# UNITED STATES PATENT AND TRADEMARK OFFICE

APPLICATION NO.	FILING DATE	FIRST NAMED INVENTOR	ATTORNEY DOCKET NO.	CONFIRMATION NO.
10/551,624	06/26/2006	Stephane Moreau	17102/023001	5504

<b>Office Action Summary</b>	<b>Application No.</b> 10/551,624	<b>Applicant(s)</b> MOREAU ET AL.	
	<b>Examiner</b> ALEXANDER B. COMLEY	<b>Art Unit</b> 3746

## **DETAILED ACTION**

FIG. 3

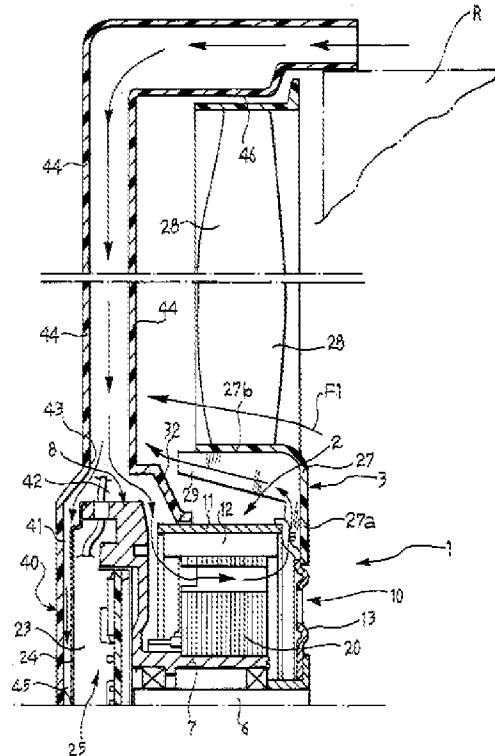
In regards to Independent **Claim 1**, and with particular reference to Figure 3 shown immediately above, Avidano discloses:

A ventilation device (1) comprising a fan (3) capable of being driven rotationally by an open electric motor (2) which is firmly attached to a support (40) intended for fixing said ventilation device (1), the fan (3) consisting of a plurality of blades (28) which are distributed regularly around a bowl (27) inside which there are arranged internal ribs (29) capable of ventilating said open electric motor (2), characterized in that the support (40) comprises a central part (24, 32) which is

connected in a substantially sealed manner to at least one peripheral portion (11) of the open electric motor (2).

As shown in Figure 3 above, Avidano et al. discloses an electric motor-driven fan unit for use in motor vehicles. Avidano's fan is designed with a hub and airflow structure that allows the fan's internal blades to cool the motor. In particular, Avidano states "A motor-driven fan includes an electric motor including a rotor and a stator in which the rotor includes an essentially cup-shaped cap which extends at least partly around the stator and has a plurality of lateral exit openings adjacent the bottom wall, and an impeller or fan including a hollow hub from which extends a plurality of main outer fan blades. This hub has a front wall fixed to the back wall of the cap of the rotor and a lateral skirt which surrounds the lateral wall of the cap in a radially spaced relationship. The hub is further provided with inner ventilation blades acting in operation to generate a cooling air stream which passes through the motor." (Abstract) Moreover, Avidano specifically describes the hub structure of Applicant's claimed invention by stating "The fan or rotor 3 of the motor-driven fan comprises a hollow hub 27 (FIG. 1) from which extends a plurality of main outer fan blades 28. The hub 27 has a front wall 27a fixed to the radial projections 15 of the disc element 13 of the cap 10, by means of rivets 29 or the like (FIG. 1). The hub 27 of the fan 3 further has a lateral, essentially cylindrical, skirt 27b which surrounds the side wall or ring 11 of the cap 10 in a radially spaced relation thereto. As is seen in FIG. 1, the hub 27 of the fan 3 is further provided, in the space 30 defined between the ring 11 of the cap 10 and the skirt 27b of the hub of the fan with internal fan blades 29 which extend in respective inclined planes with

respect to the radial direction.” (Column 2, Lines 36-48) Avidano goes on to disclose a main support body 40 with a central support 32 that serves to seal the open electric motor within the support. In particular, Avidano states "In the embodiment of FIG. 3 a rear body 40 is fixed to the stator body 8 on the side opposite the fan 3, which extends in facing and spaced relationship with respect to the cover 24 and which surrounds the periphery of the stator body 8 lying close the annular separator element 32." (Column 3, Lines 42-45) Avidano goes on to disclose a physical connection between the element 32 and the motor stator by stating, "Conveniently, although not necessarily, the motor-driven fan 1 further includes a separator ring 32 (FIG. 1) of essentially conical form, disposed around the end of the cylindrical wall 11 of the cap 10 facing the stator body 8 as well as around the ends of the cooling fins 26 of this stator body facing the fan. The separator ring 32 the function of which will be described hereinafter, can be fixed to the stator body 8 in various known ways." (Col. 2, Lines 54-61) And finally, Avidano describes the substantial sealing function provided by the element 32 in stating "This air stream discharges out by passing between the rear edge of the skirt 27b of the hub 27 of the fan and the annular separator element 32. This latter acts to impede mixing of the air stream entering the electric motor 4 with the air stream leaving it, as well as impeding the ingress of extraneous bodies or atmospheric agents into the electric motor." (Col. 3, Lines 17-24) Clearly, from these disclosures and figures, the annular separator 32 is substantially sealed to the periphery of the motor

7. In regards to dependent **Claims 2-5 & 15**, the annular separator element 32

surrounds and holds the outer periphery of the motor element 2. Moreover, it can be seen in Figure 3 that the inner edge of separator element 32 cooperates with the annular wall of the motor in a continuous, contiguous fashion, while the cover 24 cooperates with the rear portion of the motor. In particular, Avidano states "The portion of the rear body 40 facing the cover 24 of the stator is conveniently provided with at least one projection 45 in contact with this cover for the purpose of reducing or cancelling the effects of vibration." (Column 3, Lines 52-55) In regards to dependent **Claims 6-10**, it can be seen in Figure 3 that a blind hole, which surrounds and holds the rear portion of the electric motor, is formed between the annular separator element 32 and the cover 24. This opening (or hole) is attached to the rear part of the motor by tight fitting, and forms a plate around the rear portion of the motor. Regarding dependent **Claims 11-14**, the annular separator element 32 forms a surface opposite the bottom of the hub (i.e. bowl) that directs airflow from the inside of the hub to the outside of the hub (See Figure 3). Moreover, the separator has a concave shape (a quarter of a circle) that is flat, extends discontinuously (as its contour changes), and extends substantially linearly at a portion thereof. Finally, in regards to dependent **Claims 16-18**, Avidano's fan contains a peripheral part 44 that forms a frame with the central part. Moreover, Avidano's fan is for use in both an engine cooling device, as well as a motor vehicle. In particular, Avidano states "The rear body 40 may advantageously be formed integrally with a support structure to which the motor-driven fan 1 is fixed and defining a passage 46 for conveying the air stream caused in operation by the main blades 28 of the fan. In this case the aspiration duct 44 can be

9. In regards to Applicant's argument that Avidano's member 32 does not substantially seal the periphery of the motor, the Examiner must respectfully disagree. To begin, and probably most importantly of all, is the fact that the phrase "substantially sealed manner" does not require a completely air-tight seal. The phrase "substantially sealed", interpreted in the broadest reasonable manner, can simply mean a restricted flow path that limits flow more so than another portion of the structure. Nevertheless, the Examiner must assert that Avidano does, in fact, describe that the element 32 is "substantially sealed" to the motor housing. In particular, Avidano discloses a main support body 40 with a central support 32 that serves to seal the open electric motor within the support by stating "In the embodiment of FIG. 3 a rear body 40 is fixed to the stator body 8 on the side opposite the fan 3, which extends in facing and spaced relationship with respect to the cover 24 and which surrounds the periphery of the stator body 8 lying close the annular separator element 32." (Column 3, Lines 42-

45) Avidano goes on to disclose a physical connection between the element 32 and the motor stator by stating, "Conveniently, although not necessarily, the motor-driven fan 1 further includes a separator ring 32 (FIG. 1) of essentially conical form, disposed around the end of the cylindrical wall 11 of the cap 10 facing the stator body 8 as well as around the ends of the cooling fins 26 of this stator body facing the fan. The separator ring 32 the function of which will be described hereinafter, can be fixed to the stator body 8 in various known ways." (Col. 2, Lines 54-61) And finally, Avidano describes a sealing function provided by the element 32 by stating "This air stream discharges out by passing between the rear edge of the skirt 27b of the hub 27 of the fan and the annular separator element 32. This latter acts to impede mixing of the air stream entering the electric motor 4 with the air stream leaving it, as well as impeding the ingress of extraneous bodies or atmospheric agents into the electric motor." (Col. 3, Lines 17-24) Clearly, from these disclosures and the supplied figures of Avidano, the annular separator 32 is "substantially sealed" to the periphery of the motor.
